BEFORE THE PUBLIC UTILITY COMMISSION

LC 66

2016 Integrated Resource Plan

Staff Final Comments

Figure 1 – 2011 IRP Screen Shot: Load Forecast

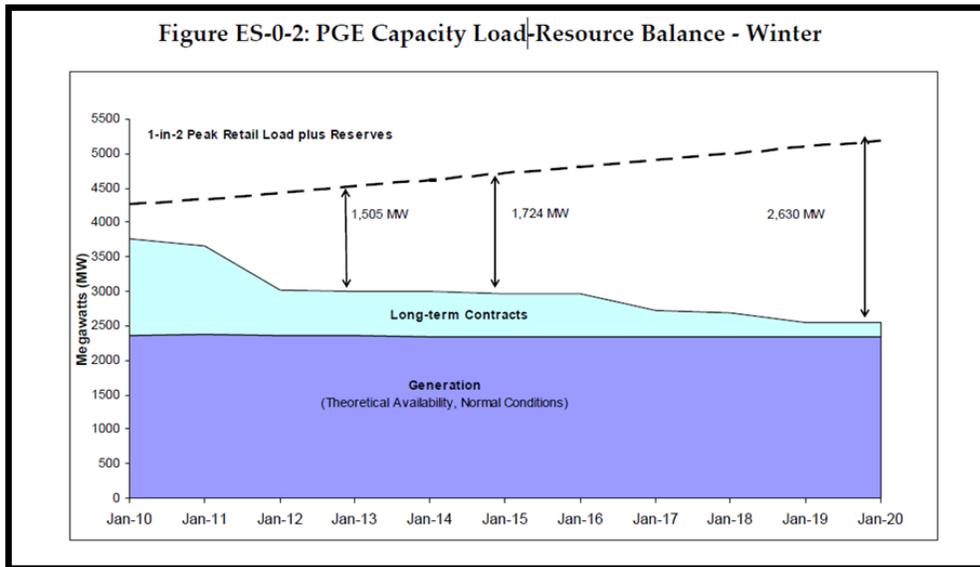
Below is a chart for the 2009 PGE IRP. In that chart, PGE demonstrates an average annual retail load deficit of 2,630 MW by the year 2020.¹⁷

PGE's graphs illustrate the inherent uncertainties in using forecasts to justify near-term actions, even for a need just ten years out, let alone 34 years. The Commission's historical emphasis on near-term needs in the context of IRP Action Plan item approval reflects the Commission's recognition of the uncertainties associated with accurate long-term forecasting. By focusing the Action Plan on near term needs, the IRP Guidelines and Commission precedent help prevent actions based exclusively on long-term forecasts that are inherently more uncertain than shorter-term projections and assumptions.

Figure 2 – 2016 IRP Screen Shot: Load Forecast

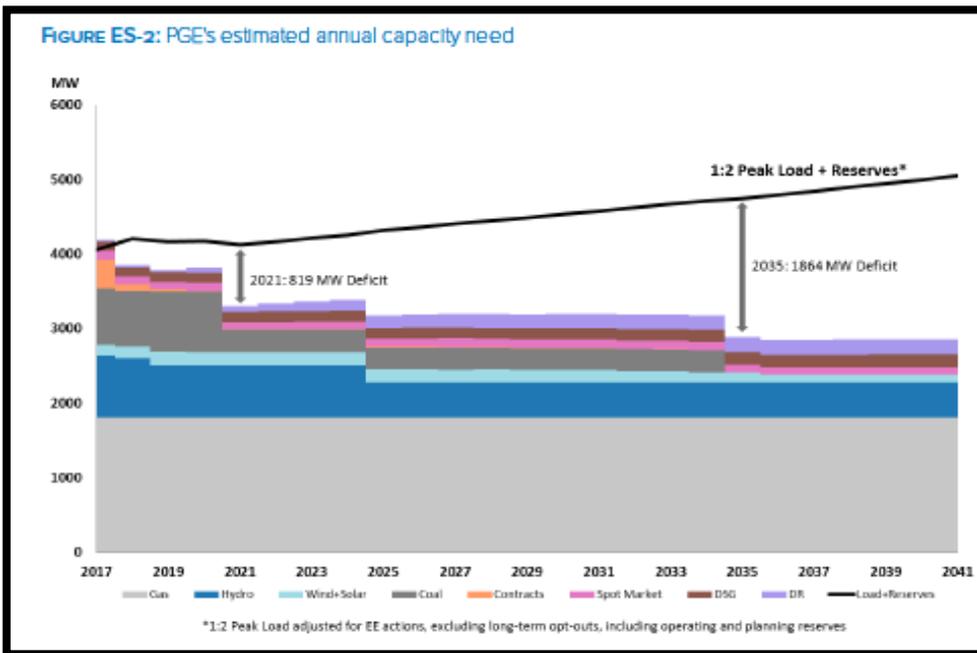
Just seven years later in its 2016 IRP, PGE predicted an 819 MW load deficit in 2021. And while the addition of Carty helped address the 2011 deficit, the fact remains that the ten-year projection of capacity need in the 2011 IRP was still off by a net 2,200 MW.

Figure 3 – 2016 IRP Screen Shot: Updated Capacity Need, 4/13/17

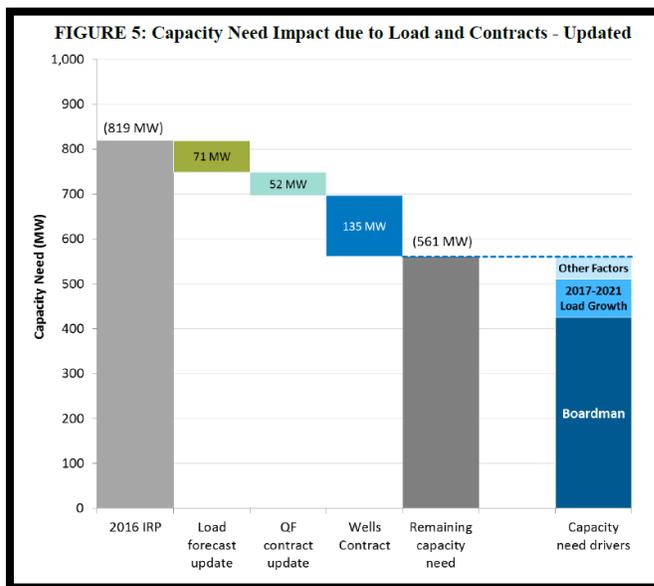
PGE's annual capacity need for the 2016 IRP was revised down (by PGE) in April 2017 from 819 MW to 561 MW due in part to bilateral negotiations to renew an existing, hydro resource.³⁴

And as stated previously, Staff recognizes PGE’s need to acquire some amount of dispatchable capacity by 2021 to meet annual peak capacity needs. Staff believes that, for this IRP, PGE’s projections for growth in its capacity need beyond 2021 should be understood to be highly uncertain, and perhaps flat, until PGE resolves the questions and concerns surrounding its load forecasting methodology.³⁵ Since PGE’s IRP was initially filed, PGE has slightly revised its Action Plan to meet its capacity needs. While PGE still plans to issue an RFP to identify and secure necessary capacity, PGE will also continue to conduct its recently launched bilateral negotiations with a select set of generators and update the Commission as these negotiations develop.³⁶

Figure 4 – Staff Analysis, PGE’s Forecasted Load Growth

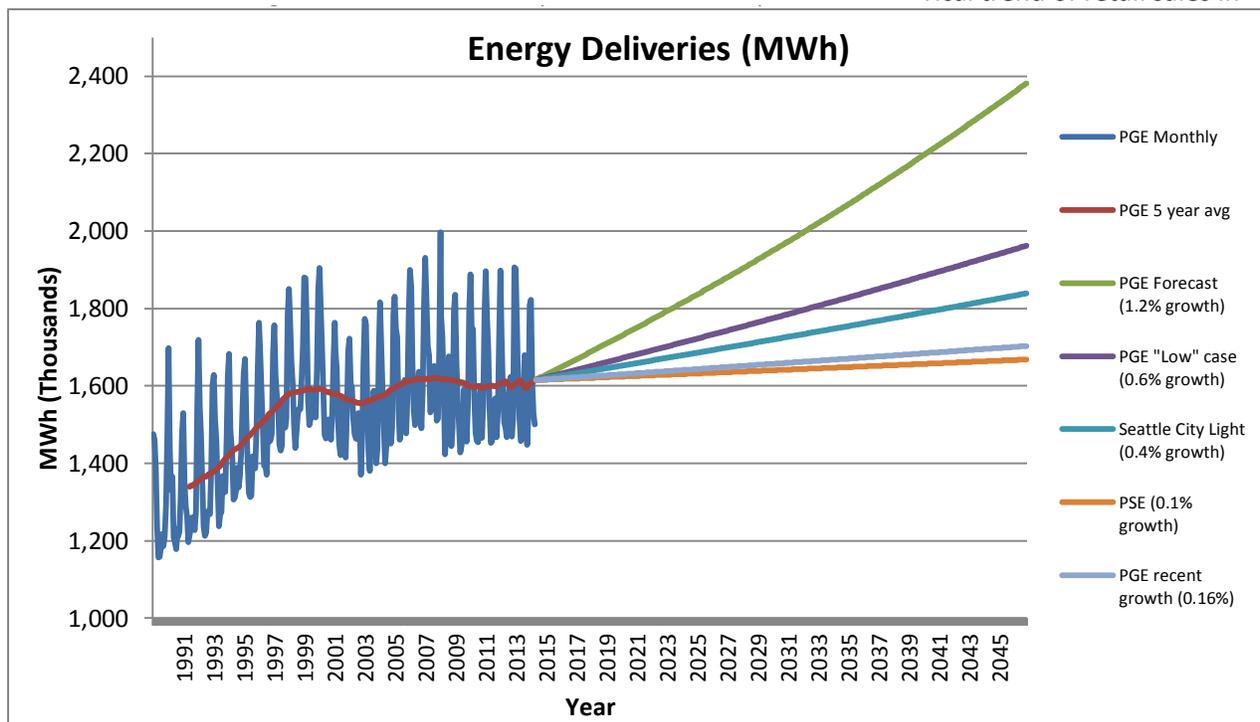
Staff is highly concerned that PGE’s load forecasting methods result in projections that greatly exceed both PGE’s recent historical load growth and the projections made by several other regional utilities. PGE estimates that its future energy deliveries will grow over the long-term at an annual rate of 1.2 percent. This stands in stark contrast to the load growth expected by other regional utilities. For example, Seattle City Light expects to experience 0.4 percent annual growth⁶⁶ while Puget Sound Energy anticipates 0.1 percent annual growth.⁶⁷ Even PGE’s “low” scenario of 0.6 percent annual growth exceeds these base-case growth rates anticipated by both Seattle City Light and Puget Sound Energy.

Staff also believes that PGE’s recent historical load growth should be considered a credible scenario for its future load growth. PGE’s average monthly load for residential, commercial, and industrial customers combined was about 1.65 percent greater in the 2010-2014 period than it was in the corresponding period 10 years earlier (i.e., 2000 to 2004).⁶⁸ This corresponds to an average annual growth rate of 0.016 percent, which is considerably smaller than even the “low” growth scenario PGE considers in its IRP. The following figure depicts how these potential scenarios could develop by projecting the various growth rates used by other utilities from PGE’s historical load data.

Figure 5 – Historic Monthly Electricity Sales, Oregon

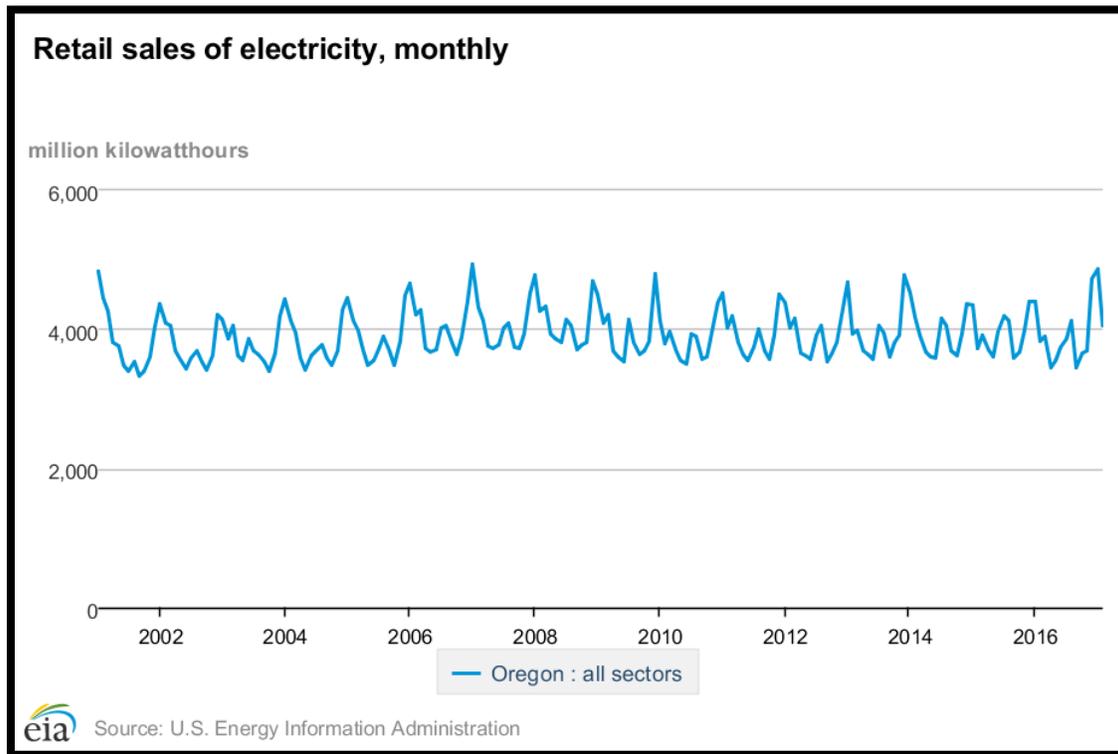
Oregon as measured by the EIA and depicted in the figure below.⁶⁹

Figure 6 – 2016 IRP Screen Shot: Forecasted Energy & Capacity Need

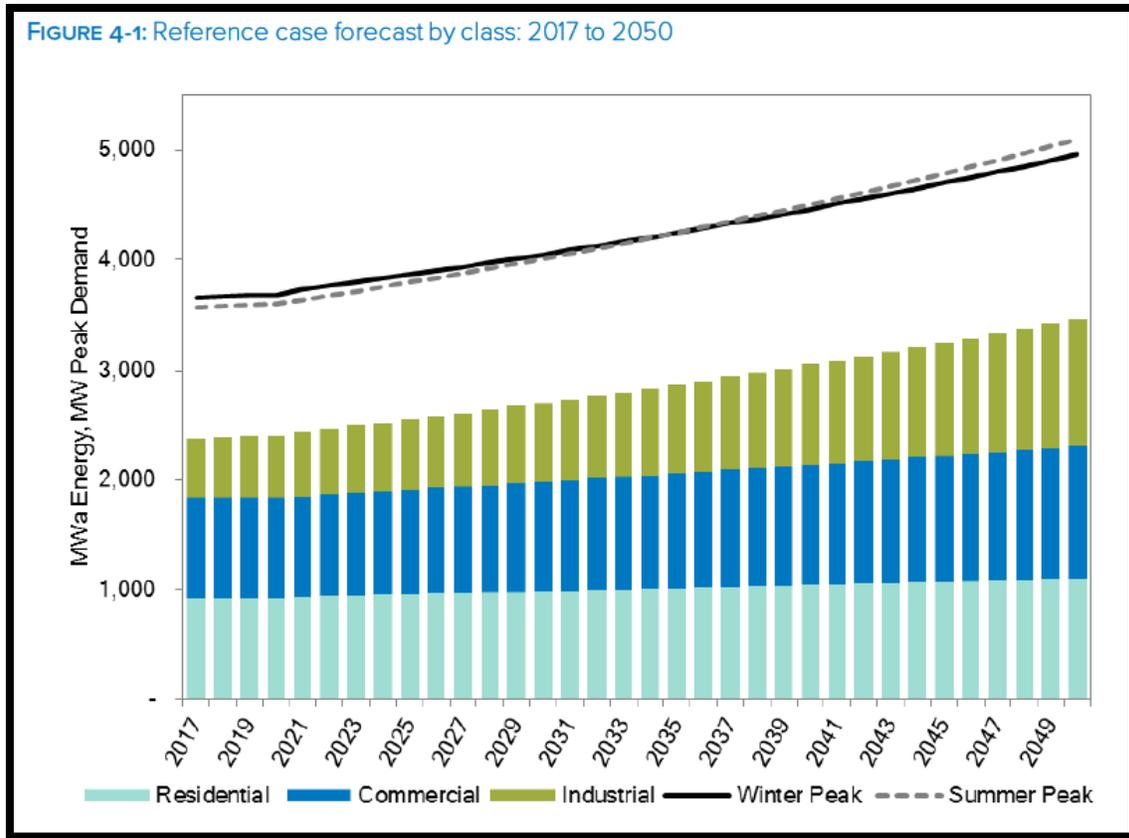
It is also concerning that PGE projects accelerating growth in energy deliveries despite the fact that the forecasts of GDP and employment that PGE uses *decelerate* (from 2.6 percent growth for GDP through 2020, down to 2.3 percent thereafter,⁷⁰ and from “as high as 3 percent in the very near term” for employment, down to 1 percent in the long-term⁷¹). This can be seen in the “kink” at 2001 in the trends depicted in Figure 4.1 from PGE’s IRP:

Figure 7 – Staff Analysis: Scatterplot of Changes, GDP & Industrial Load

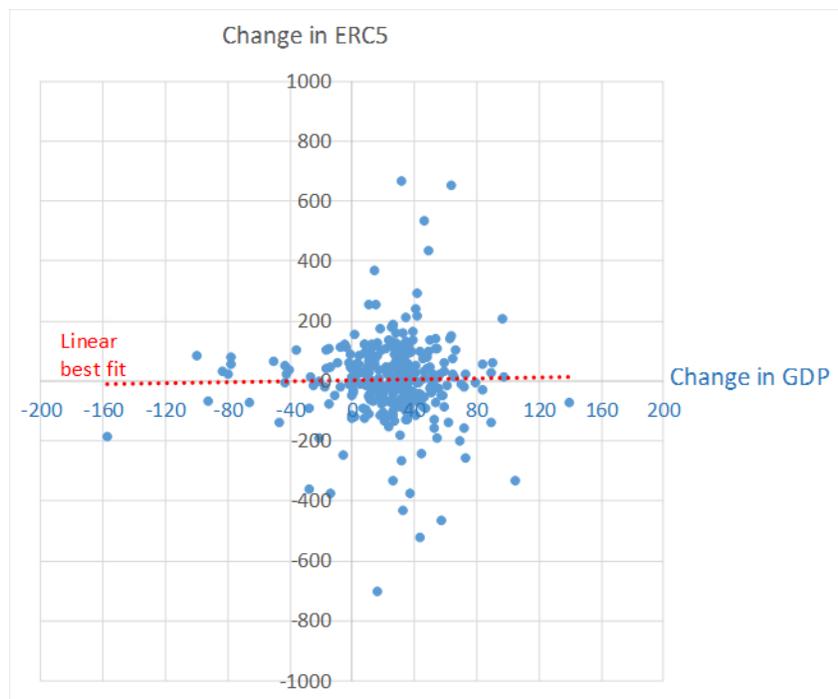
Second, Staff believes there is evidence of a very different relationship between GDP and PGE’s load than the one suggested by PGE’s estimates. If GDP drives load, then one would expect an increase in GDP from one month to the next to correspond to an increase in load, holding all else constant. The figure below shows that this is unlikely to be the case. It plots *changes* in GDP from one month to the next versus *changes* in PGE’s industrial load. There is no clear pattern in between these changes, as demonstrated by the essentially flat best-fit line through these data. Moving along the x-axis, for any given change in GDP, load changes essentially randomly along the y-axis. The figure shows that for each month in which GDP increased, load was essentially equally likely to increase or decrease. This is in direct opposition to PGE’s estimated coefficient of GDP on load.

Figure 9 – Industrial Energy Deliveries and GDP

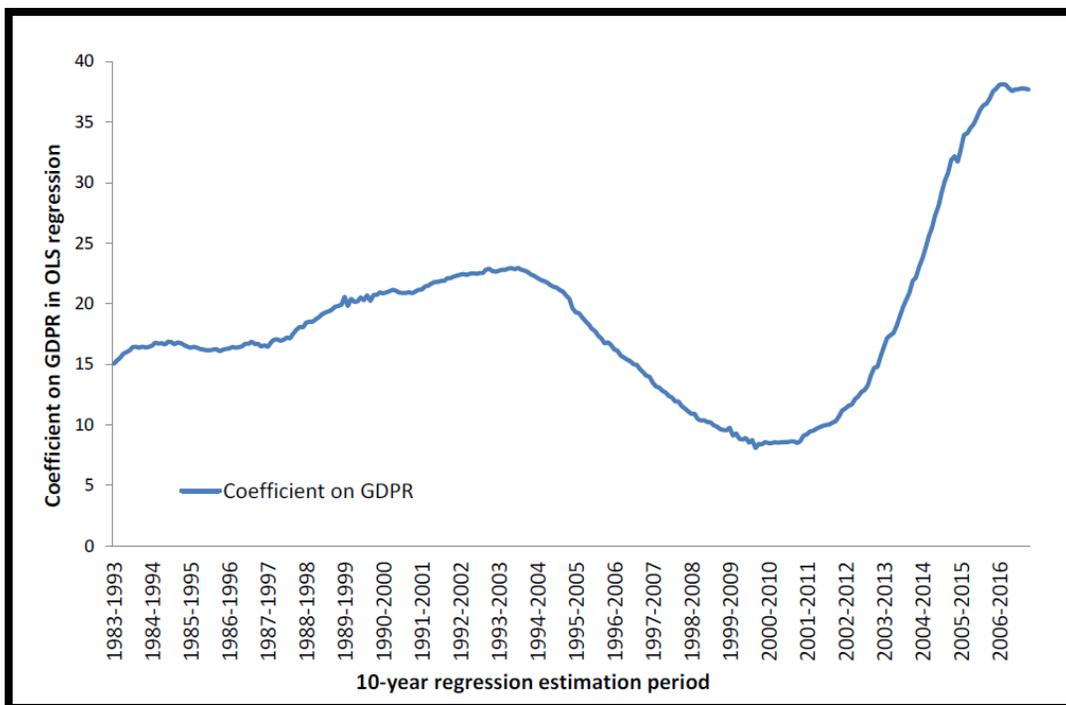
The overconfidence that PGE places in its estimates is clearly revealed by the relationship PGE estimates between GDP and industrial load. The 99 percent confidence interval for this relationship implied by PGE’s methods is from 19.3 to 21.3 (MWh per \$1 billion US GDP).⁸⁰ This is surprisingly narrow, as revealed by Figure 2 from PGE’s reply to OPUC DR 123. This figure demonstrates that this relationship ranges from below 10 to above 35, depending on the time-period of data used.

It is important to note that Staff has not reviewed the methods by which PGE constructed this figure, which, if consistent with PGE’s other methods, would also be subject to Staff’s concerns about incorrect correlations (as explained in Staff’s Initial Comments). Nonetheless, it reveals that even disregarding these concerns, there is internal evidence within PGE’s methods that the precision of its estimates is overstated.
